Re: DUBLIN: VSA Tunning

Here is an update on the activities at Valmiera VSA at Dublin, Ga.

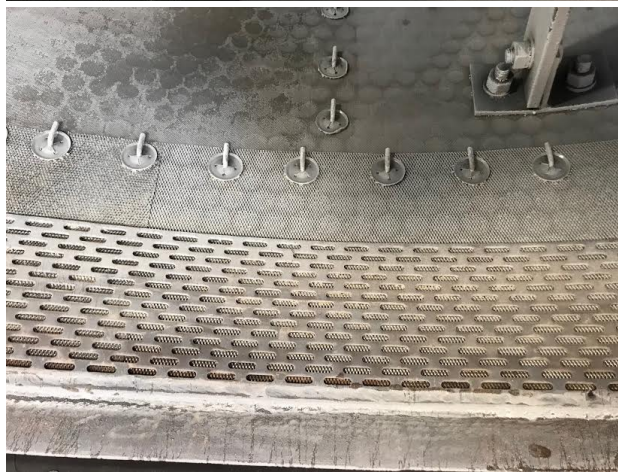
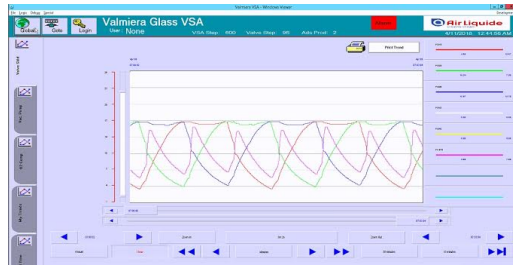
I did not see any big level trouble with these pictures.

I am also attaching some photos during the filling of the adsorber columns. If I find more photos I will send them to you.

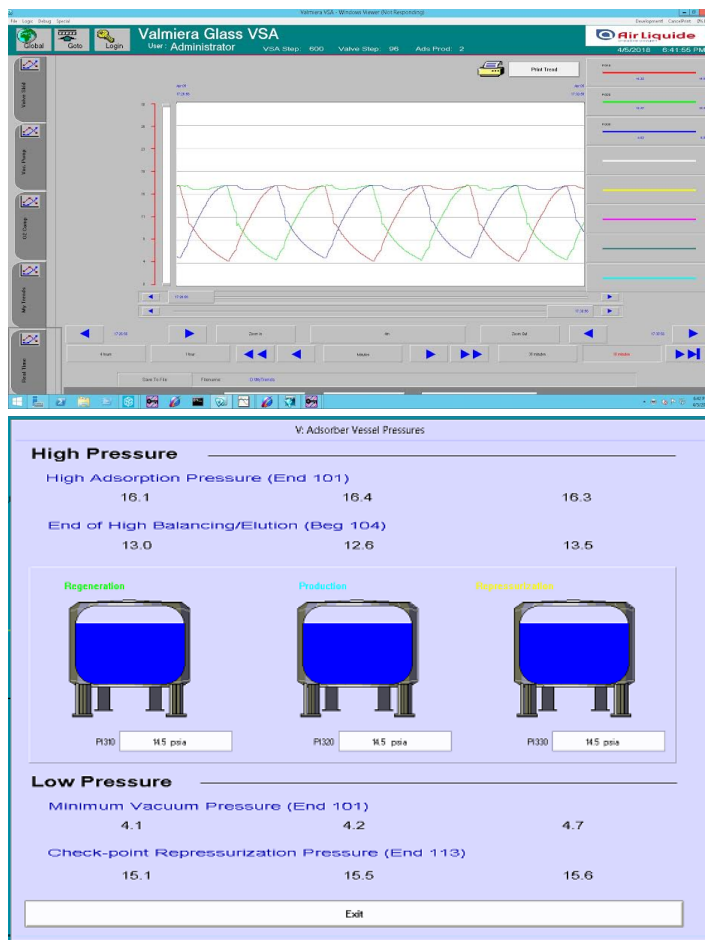
We ran the VSA yesterday with the changed cycle times as shown in the last column of the below photo,

The highlighted are the steps times we changed to for the VSA run.

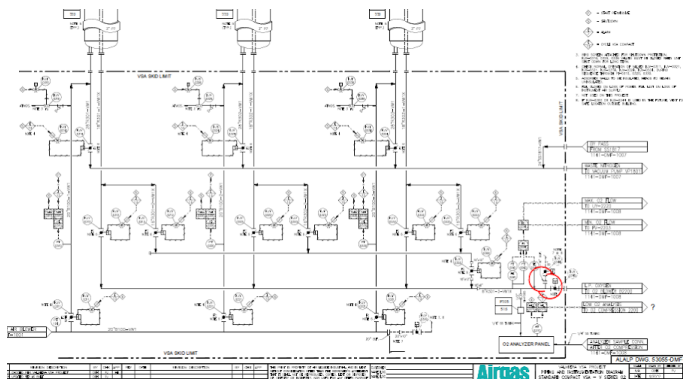
- Check the O2 header from the VSA skid for any Sieves, dust.
 - O2 header checked by opening 8" blind flange. No Sieves or dusting was seen in the pipe. See attached photos for the pipe internals. See clouded portion where the O2 header was opened.
 -
